JOSEPH M. FARLEY NUCLEAR PLANT, UNIT 2

AMENDMENT TO FACILITY OPERATING LICENSE

Amendment No. 94  
License No. NPF-8

ATTACHMENT TO LICENSE AMENDMENT NO. 94

FIGURE 3.4-1

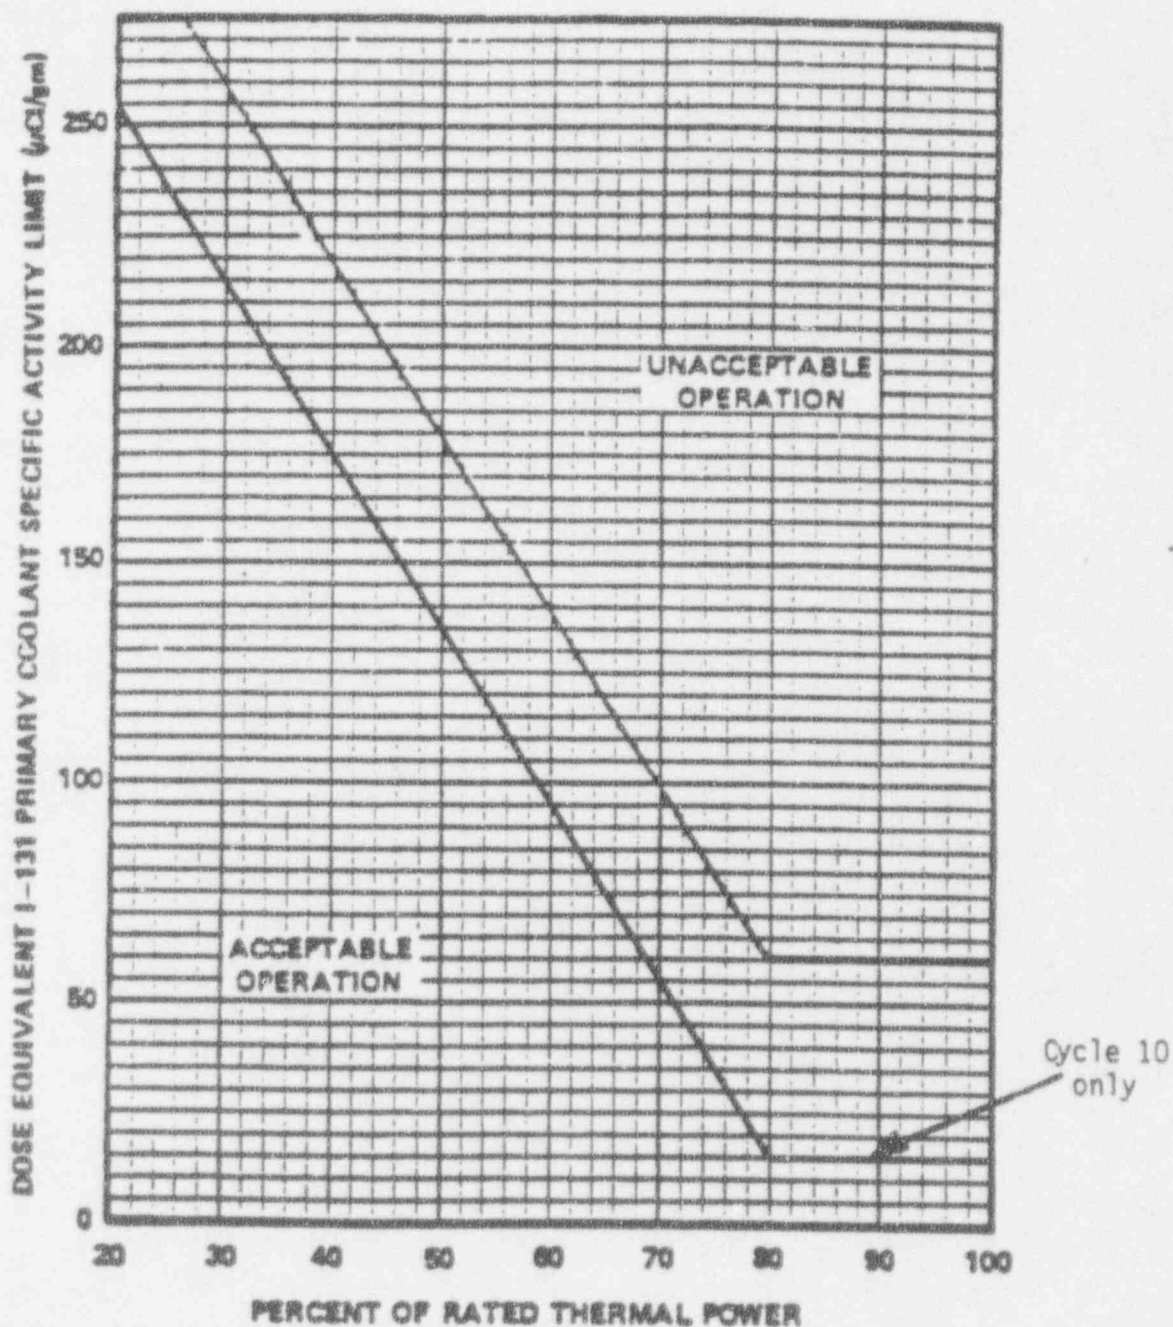
- a. For the Tenth Operating Cycle only, with the specific activity of the primary coolant greater than 0.25 microCurie per gram DOSE EQUIVALENT I-131 for more than 48 hours during one continuous time interval or exceeding the limit line shown on Figure 3.4-1, be in at least HOT STANDBY with  $T_{avg}$  less than 500°F within 6 hours.
- b. For subsequent cycles, with the specific activity of the primary coolant greater than 1.0 microCurie per gram DOSE EQUIVALENT I-131 for more than 48 hours during one continuous time interval or exceeding the limit line shown on Figure 3.4-1, be in at least HOT STANDBY with  $T_{avg}$  less than 500°F within 6 hours.
- c. With the specific activity of the primary coolant greater than  $100/\bar{E}$  microCurie per gram, be in at least HOT STANDBY with  $T_{avg}$  less than 500°F within 6 hours.

(Activity  $> .25 \mu\text{Ci/gram}$  Dose Equivalent I-131 for Cycle 10 only.)
